2.4 Core Cooling Systems

The information in this section of the reference ABWR DCD, including all subsections, tables, and figures, is incorporated by reference with the following departures.

STD DEP T1 2.4-1 (Figure 2.4.1a, Table 2.4.1)

STD DEP T1 2.14-1 (Figure 2.4.1b, Figure 2.4.1c, Figure 2.4.3)

Figure 2.4.1a Residual Heat Removal System (RHR-A)

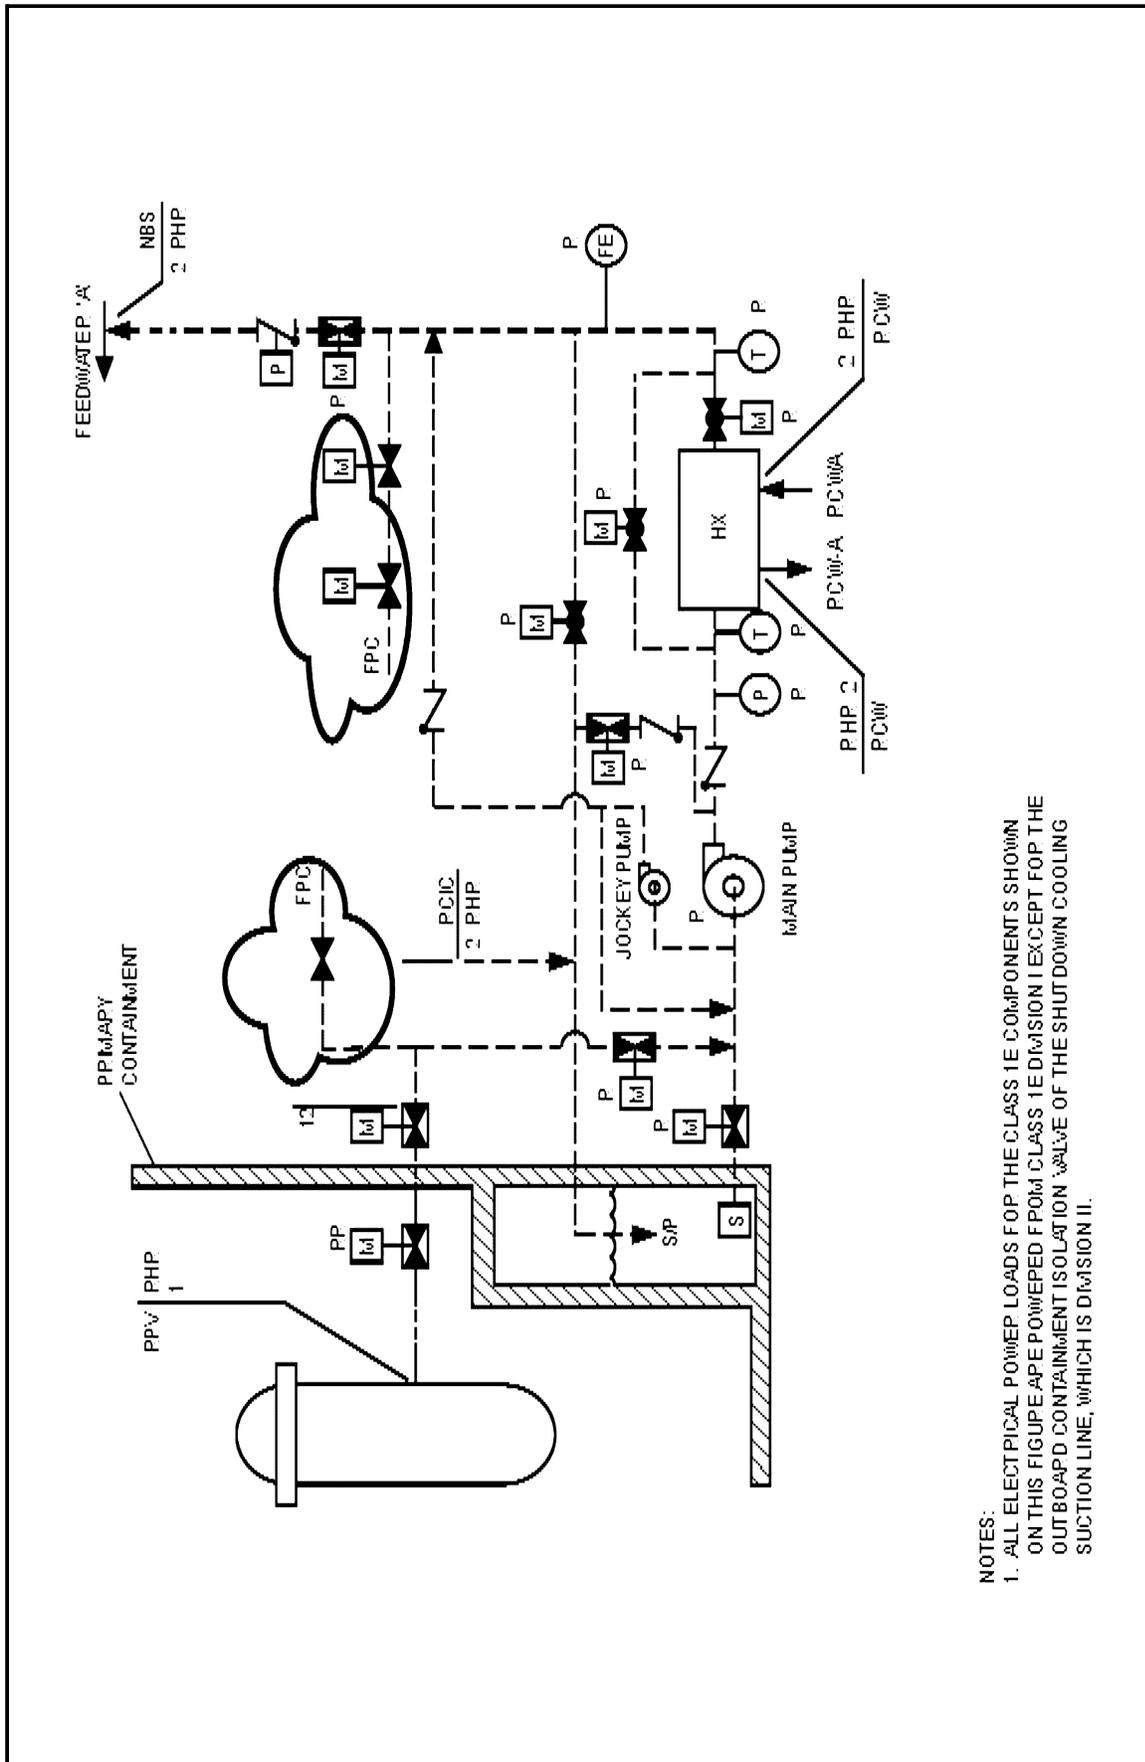
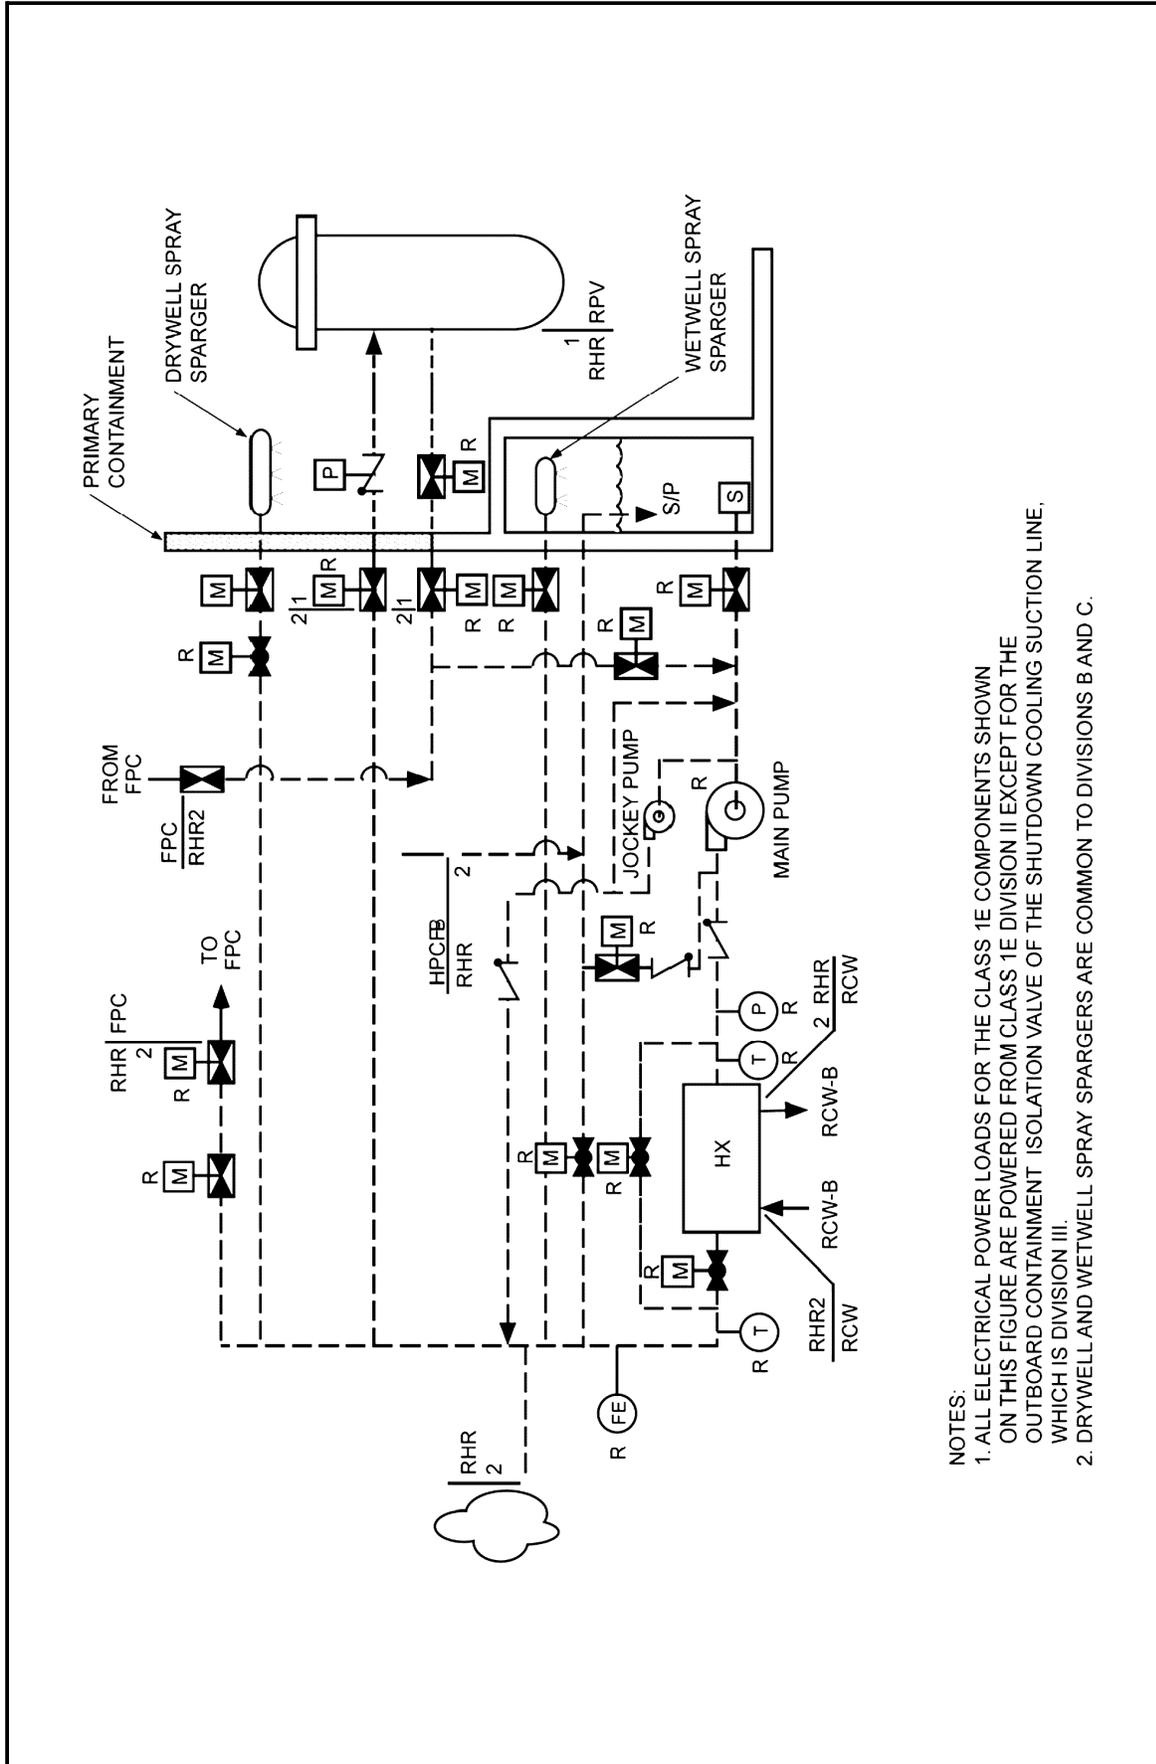
STD DEP T1 2.4-1

The augmented fuel pool cooling mode of the RHR System (Divisions A, B and C) can supplement the Fuel Pool Cooling (FPC) System as follows: (1) directly cooling the fuel pool by circulation fuel pool water through the RHR heat exchanger and returning it to the fuel pool; and (2) while providing shutdown cooling during refueling operations, return the cooled RHR shutdown cooling flow to the fuel pool. Also, this mode provides for fuel pool emergency makeup capability by permitting the RHR pumps (Divisions A, B and C) to transfer suppression pool water to the fuel pool. This mode is accomplished manually by control of individual system components. In the augmented fuel pool cooling mode, the RHR tube side heat exchanger flow rate for Divisions A, B or C is no less than 350 m³/h.

The piping and components outside the shutdown cooling suction line containment isolation valves and outside the suppression pool containment isolation valves, and upstream of the suction side of the pump with all its branches have a design pressure of 2.82 MPaG for intersystem LOCA (ISLOCA) conditions. Refer to Figures 2.4.1a, 2.4.1b, and 2.4.1c. ~~For RHR-A, the upgraded branch lines from the main pump suction include the path to and including the suppression pool suction valve, the path to the shutdown cooling outboard containment isolation valve, and the path to the jockey pump's discharge check valve including the jockey pump's bypass return line. For RHR-B and C, the upgraded branch lines include all the paths listed for RHR-A plus the path to (and including the valve) the Fuel Pool Cooling System that branches off the shutdown cooling suction line, titled "From FPC."~~ For RHR A and B, the upgraded branch lines from the main pump suction include the path to and including the suppression pool suction valve, the path to the shutdown cooling outboard containment isolation valve, the path to the jockey pump's discharge valve including the jockey pump's

bypass line and the path to the (and including the valve) the Fuel Pool Cooling System that branches off the shutdown cooling suction, titled, "From FPC". For RHR-C, the upgraded branch lines include all the paths listed for RHR-A and B plus the pipeline and valves that are part of the AC independent water addition mode that extends from the noncode boundary indicated by "NNS" to the "external connection" outside the "reactor building" and to the Fire Protection System interface indicated by "FP".

Figure 2.4.3 Leak Detection and Isolation System Interface Diagram

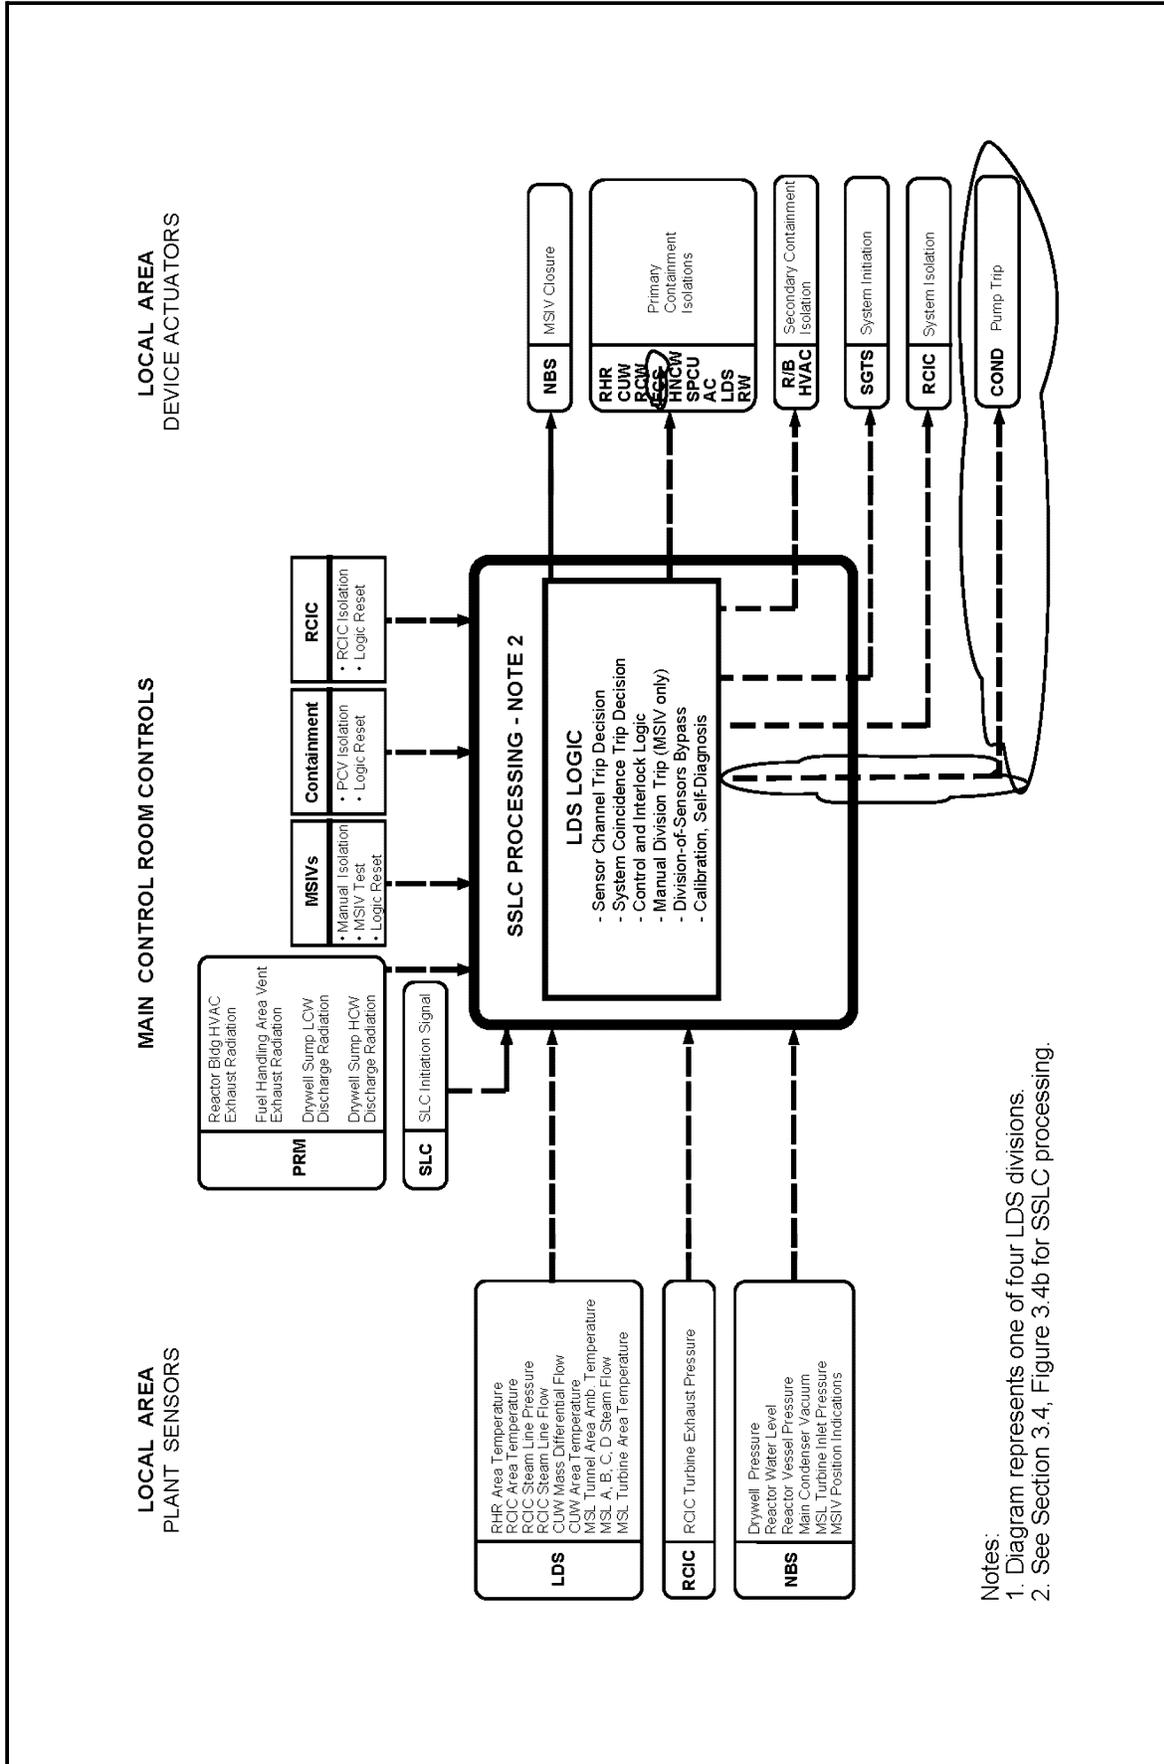
STD DEP T1 2.14-1 (FCS, Figure 2.4.3)

- (9) *Isolation of the Suppression Pool Cleanup (SPCU) System on a signal indicating high drywell pressure or low reactor water level.*
- ~~(10) *Isolation of the Flammability Control System (FCS) on a signal indicating high drywell pressure or low reactor water level.*~~

- (10) ~~(11)~~ *Isolation of the drywell sump low conductivity waste (LCW) and high conductivity waste (HCW) discharge lines on a signal indicating high drywell pressure or low reactor water level. Also, each discharge line is individually isolated on a signal indicating high radioactivity in the discharged liquid waste; only one channel is used for this function.*

- (12) ~~(13)~~ *The LDS provides to the neutron monitoring system a signal indicating a high drywell pressure or low reactor water level.*
- (13) The LDS provides a trip of the condensate pumps on signals that indicate high drywell pressure and high differential pressure between the feedwater lines.
